MWO 1-1520-238-20-02

### MODIFICATION WORK ORDER

# MODIFICATION OF ATTACK HELICOPTER AH-64A TO REPLACE M43 SLIDE MOUNT BRACKET ASSEMBLY P/N 5-1-1317 WITH M48 BRACKET ASSEMBLY, KEVLAR PANEL P/N 5-1-3502 NSN 1520-01-106-9519

U.S. Army Aviation and Missile Command 19 December 2002

Figure 1

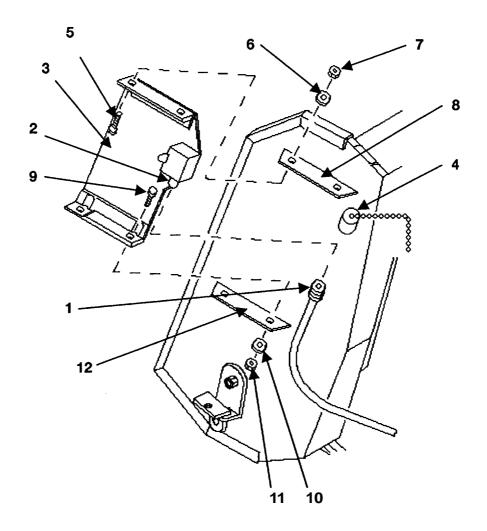
- (3) Disconnect connector (1) P993 (pilot) or P997 (CPG) from connector (2) (A148)J1 or (A147)J1 (CPG) on slider plate (3).
- (4) Screw electrical connector cover (4) onto connector P993/P997.
- (5) Remove and discard two screws (5), two washers (6) and two nuts (7) from upper bracket (8).
- (6) Remove and discard two screws (9), two washers (10) and two nuts (11) from lower bracket (12).
- (7) Remove M43 Mask Blower slider plate (3) from brackets.

Figure 2

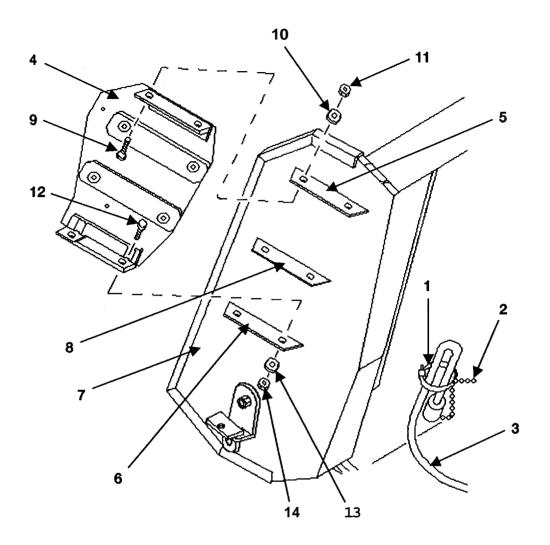
- (1) Thread the tiedown strap (1) through one of the links on the electrical connector cover chain (2).
- (2) Fold approximately four inches of the cable (3) onto itself, and tighten the tiedown strap.
- (3) Install new bracket assembly (4) into existing upper bracket (5) and lower bracket (6) on left armored wing (7) of crew seat.

- (4) Install or remove laminated shims (8) (as required) from lower bracket so that slider plate will attain a tight fit.
- (5) Installtwo .190–32UNF, .75 LG machine screws (9) through upper bracket with screw heads on the inside of the bracket.

- (6) Install two No. 10, Type A flat washers (10) and two .190–32SUNF hex nuts (11) on screws and hand tighten.
- (7) Install two .190–32UNF, .75 LG machine screws (12) through lower bracket with screw heads on the inside of the bracket.

- (8) Installtwo **No.** 10, Type A flat washers (13) and two .190–32SUNF hex nuts (14) on screws and hand tighten.
- (9) Torque four nuts to 25 INCH-POUNDS.
